Application No.: A07/26

Municipal Address: **137 Riverbank Drive**

Proposal:

Staff Comments

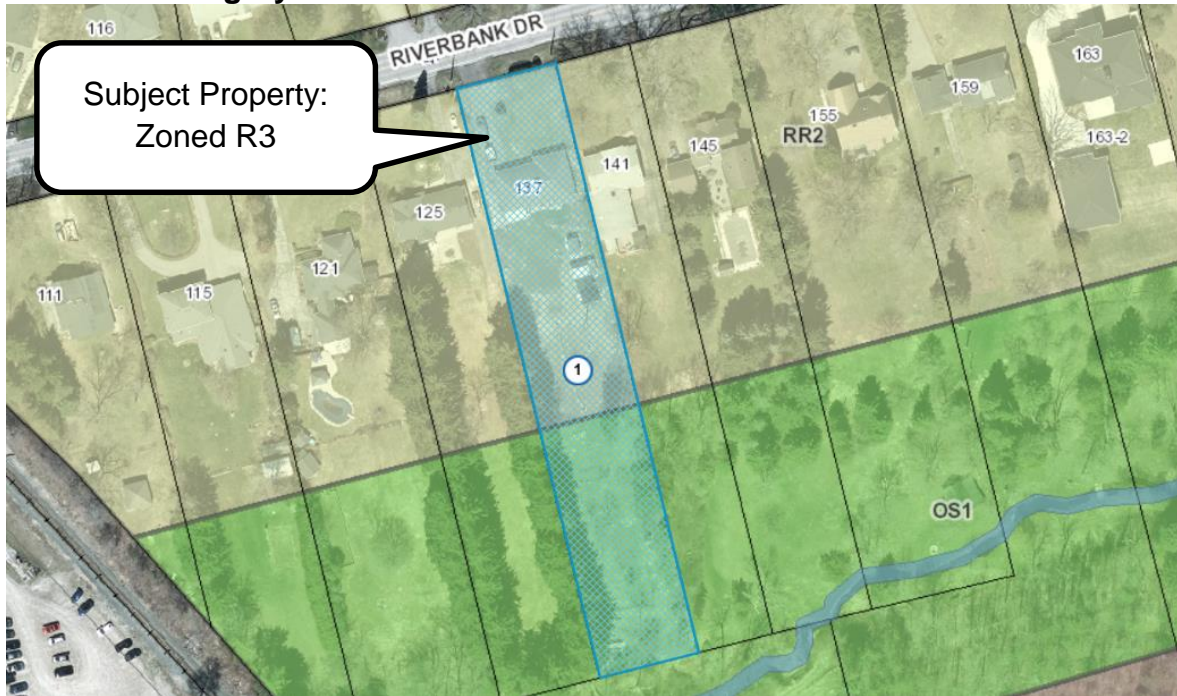
Information currently available at this office indicates that the subject property contains floodplain and the regulated allowance adjacent to the floodplain. A copy of GRCA's resource mapping is attached.

Due to the presence of the features noted above, a portion of the property is regulated by the GRCA under Ontario Regulation 41/24 – Prohibited Activities, Exemptions and Permits Regulation. Any future development or other alteration within the regulated area will require prior written approval from GRCA in the form of a permit pursuant to Ontario Regulation 41/24.

The proposed minor variance application requests permission to allow an increased building height and distance from the street for a proposed ARU. Based on our review of the circulated plans, the proposed ARU will be outside of the regulated area noted above. As such, the GRCA has no objection to the approval of this minor variance application.

While the GRCA does not object to this application, the applicant is advised that more detailed plans and a proposed septic system design will be needed to determine if a GRCA permit will be required for the proposed development.
